CitiPower, Powercor and United Energy ('CPU') 2026 - 2031
Regulatory Proposals

REVIEW OF PROPOSED EXPENDITURE ON ICT AND CER

Report prepared for:
**AUSTRALIAN ENERGY
REGULATOR (AER)**
August 2025

Figure 3.2: Comparison of CPU end user device expenditure – current and next RCPs - \$m, 2026

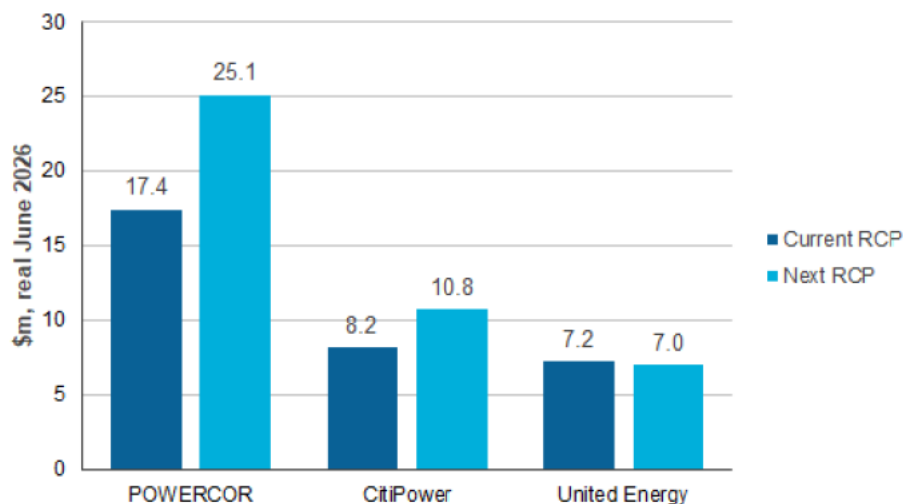
CPU provided the basis for the variance to the historical spend in response to our information request

146. Due to the lack of information about the significant variance between the current period forecast spend and the proposed capex for the next RCP in the business case and model, we asked CPU to explain via an information request. The key information from CPU's response is shown in Figure 3.3.

147. We consider that the qualitative explanation above is not sufficient to support the significant uplift in proposed expenditure by CitiPower and Powercor. A quantified variance analysis

Figure 3.7: CP + PAL market compliance and market systems totex – historical and forecast for next RCP –\$m, 2026 (without labour escalation)*

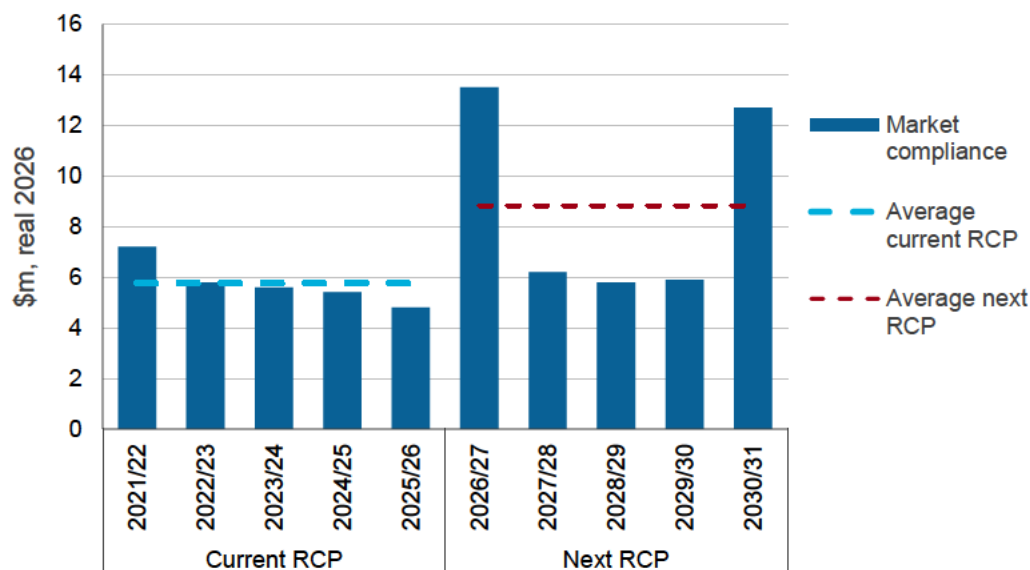
195. We show by way of example the historical and forecast information for CP/PAL in Figure 3.7. The spikes in expenditure in the next RCP profile are likely from the proposed market systems recurrent capex. The inference is that the market compliance expenditure on its own is higher in the next RCP than in the current RCP, however we are not able to determine by how much.

196. PAL states that ‘...there is a clear increasing trend in our RIN data linked to the growing number of system modifications required to ensure we meet our compliance obligations.’⁵⁰ However, this is not evident from the historical data presented.

Figure 3.16: PAL - ERP & Billing program expenditure profile – Option 3 - next RCP - \$m, real 2026

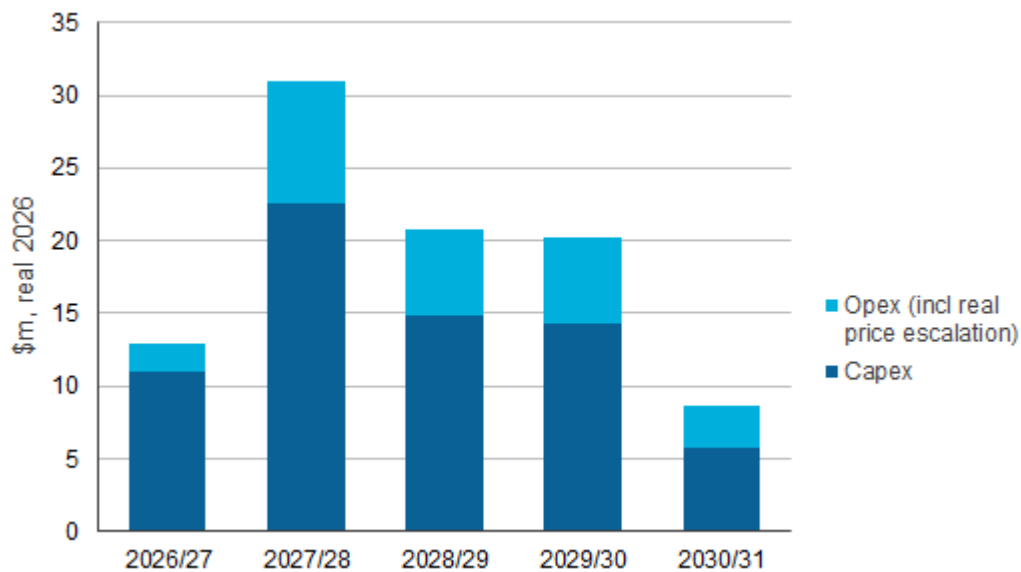
CPU has provided a reasonable cost analysis for the next RCP, however costs incurred in the current RCP are not explicit and have not been included in the CBA model

287. Figure 3.16 shows the Powercor expenditure profile for CPU's preferred Option 3. CitiPower's expenditure profile is similar to Powercor's, peaking in FY27/8 at \$10.1 million. UE's expenditure profile has peak expenditure in FY29 (\$23.4 million) and FY30 (\$26.9 million). In all three cases, work tapers off to FY31, which is consistent with the implementation schedule.

Figure 4.4: CitiPower percentage of customers with intrinsic hosting capacity (kW)

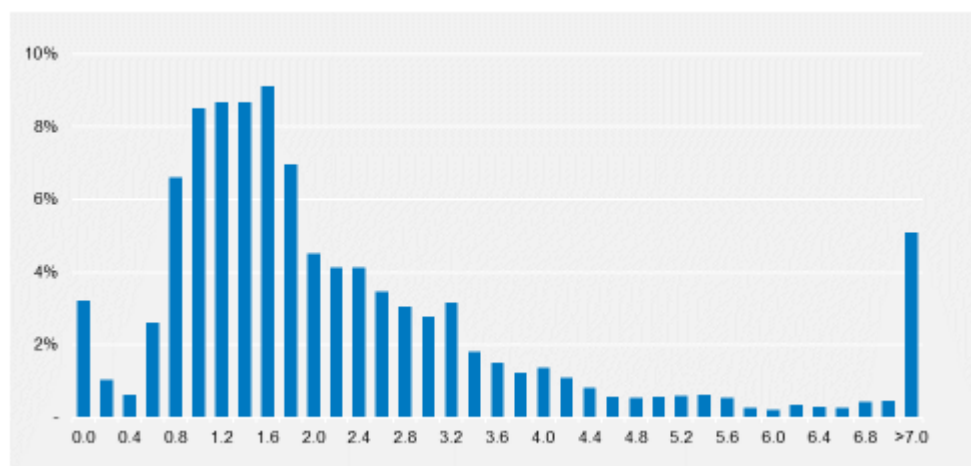
Under a 'non-intervention' option (i.e. Option 1) CPU would need to impose increasingly onerous export limits, resulting in curtailed exports and limitations on imports

380. In presenting its assessment of the option of maintaining static controls, the diagram shown in Figure 4.4 is included in CitiPower's business case showing the distribution of intrinsic hosting capacity. For CitiPower, the business case states that its analysis shows it to have a median intrinsic hosting capacity of 1.6kW; the equivalent figures are 1.4kW for Powercor and 1.5kW for United Energy.¹¹⁶
381. CitiPower states that it currently has 460MW of available hosting capacity on its network, and United Energy 1,060 MW but that they expect this to become more utilised over the next regulatory period. Powercor states that it has 1,350 MW of hosting capacity, but that this is already 96% utilised.¹¹⁷

Figure 4.5: Cumulative net benefits for CitiPower’s proposed flexible services program, including with EMCa indicative modelling corrections - \$m, real 2026

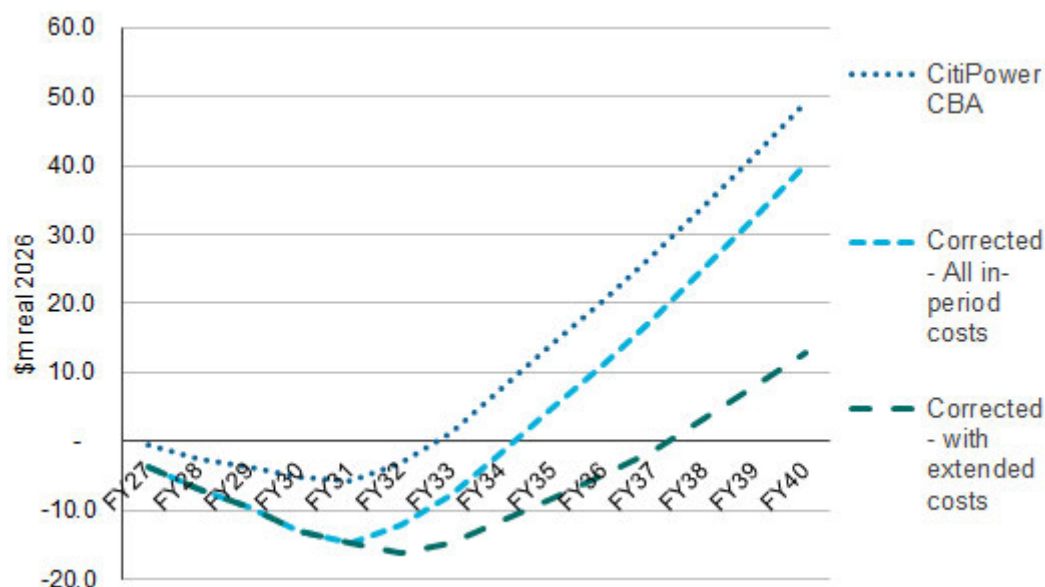
- Firstly, we have included all ‘in period’ costs, and
- Secondly, we have also included an estimate of costs extending to 2040. For this purpose, we have assumed that:
 - CitiPower’s opex in 2031 continues at the same level, and
 - CitiPower’s capex is extended by including ‘refresh’ costs starting in 2032 that are 50% of the original costs 5 years prior.

393. With these corrections, CitiPower’s proposal still breaks even within the analysis period, but with a considerably lower cumulative net benefit than is shown in its model at \$5m, rather than the \$25m claimed in its business case.

Figure 4.6: CitiPower forecast of flexible services benefits (option 3) - \$m, real 2026

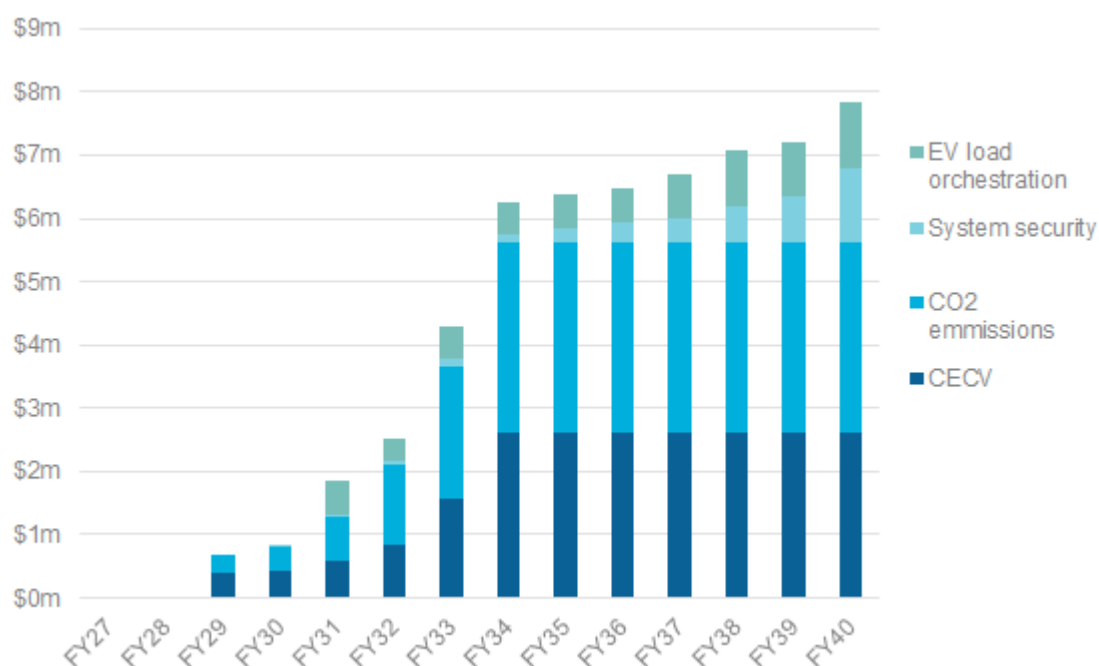
398. In Figure 4.6 we show CitiPower's assessment of the benefits of its flexible services program. In aggregate, we consider that this is a reasonable forecast based on reasonable assumptions and the methodology that is described in the business case.
399. We also consider that the analysis period to 2040 is reasonable. By that time, flexible exports will have been in place for 13 years and flexible imports 9 years. This analysis period provides sufficient time for the benefits of these programs to be evident, but not so much time as to render them unreasonable on the basis of future uncertainty.

Figure 4.9: Powercor – Forecast annual augmentation deferred (from assumed Non-network marketplace) - \$m

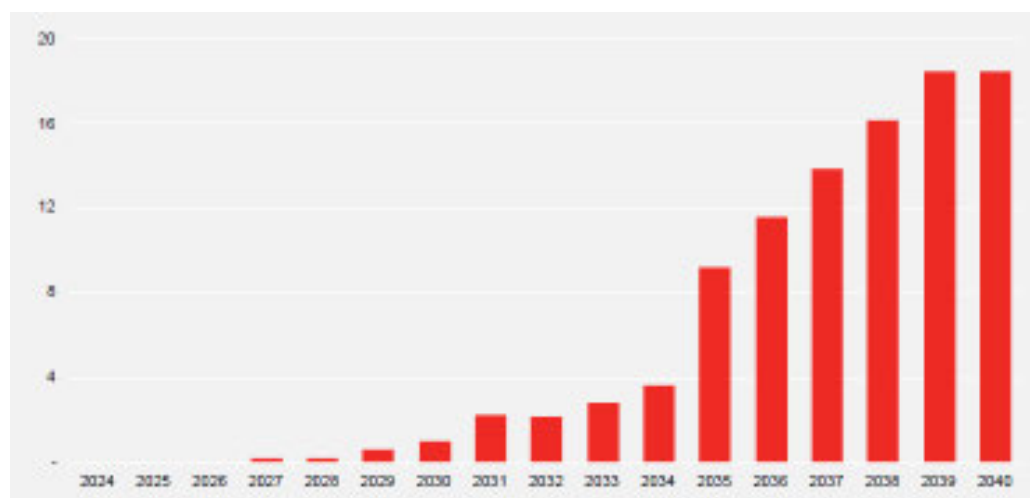
434. CPU’s business case is realistic at least insofar as it assumes that benefits will likely not be realised in the medium term. However, this also raises a significant question as to whether it is necessary to invest in such a marketplace now, given the inevitability of significant changes in the ‘energy transition’ landscape, including technology change and other changes in the regulatory and government policy framework that will occur over this period. There is an option value to delay.

435. In Figure 4.9, we reproduce Powercor’s graph showing its estimate of benefits from the proposed non-network marketplace.¹³⁴ As can be seen here, Powercor’s forecast is that the benefits will only start to ramp up from around 2035. Benefits will be negligible within the next RCP.
